**City of Bellevue  
Development Services Department  
Land Use Staff Report**

**Proposal Name:** Bloch Cabana

**Proposal Description:** Critical Areas Land Use Permit to construct a 663 square foot cabana within a steep slope critical area, buffer, and setback and with impacts to the shoreline setback from Lake Washington. Mitigation is proposed on the steep slope through planting and along the shoreline of the property through removal of the existing bulkhead and creation of a laid back shoreline cove.

**File Number:** 15-125705-LO

Figure 4

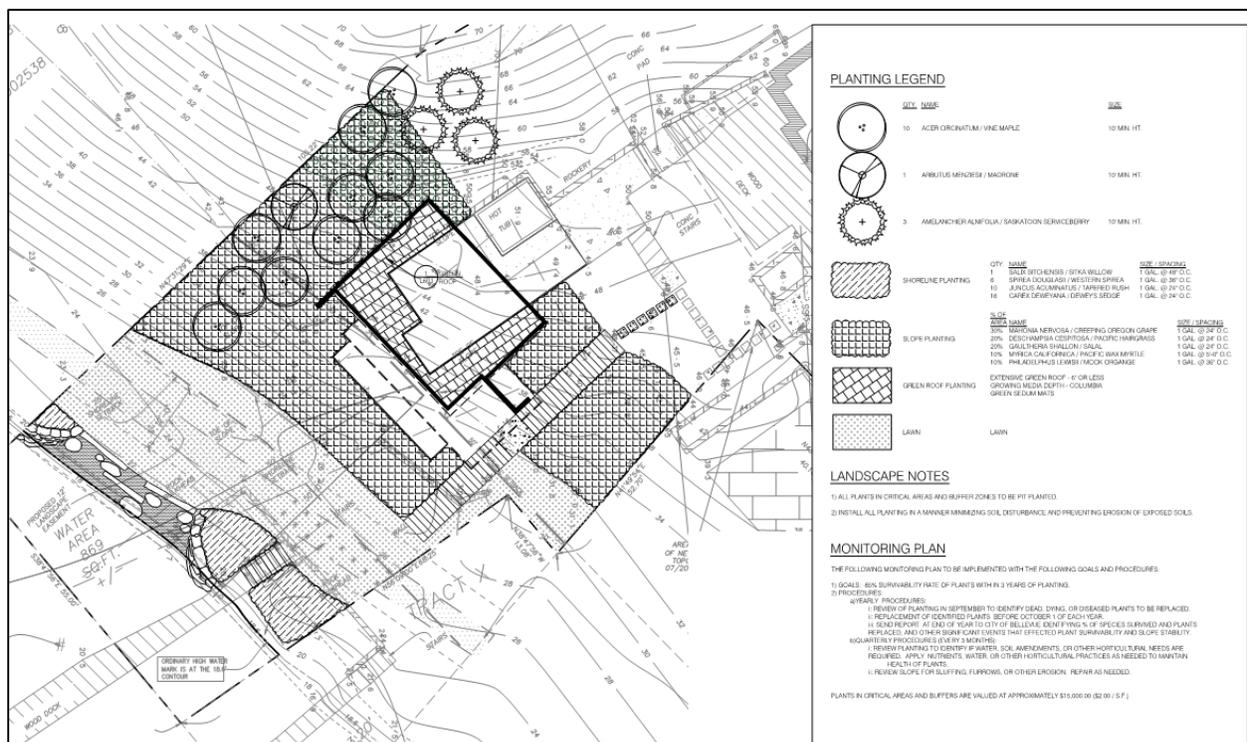
Mitigation planting is required to be monitored for five years. The mitigation plan submitted notes a three year monitoring. The plan submitted with the construction permits is required to show a five year plan. The monitoring component is approved as conceptual and the final monitoring plan must provide measures and goals for five years. A maintenance surety is required to be provided which is 100 percent of the cost estimated to maintain and monitor the plants for five years. **See Condition of Approval in Section X of this report.**

A report on shoreline restoration plant health, survival, and maintenance activity shall be submitted yearly for five years. The monitoring plan is required to be revised to provide monitoring for a full five years, rather than three years, with appropriate goals and standards for each year.
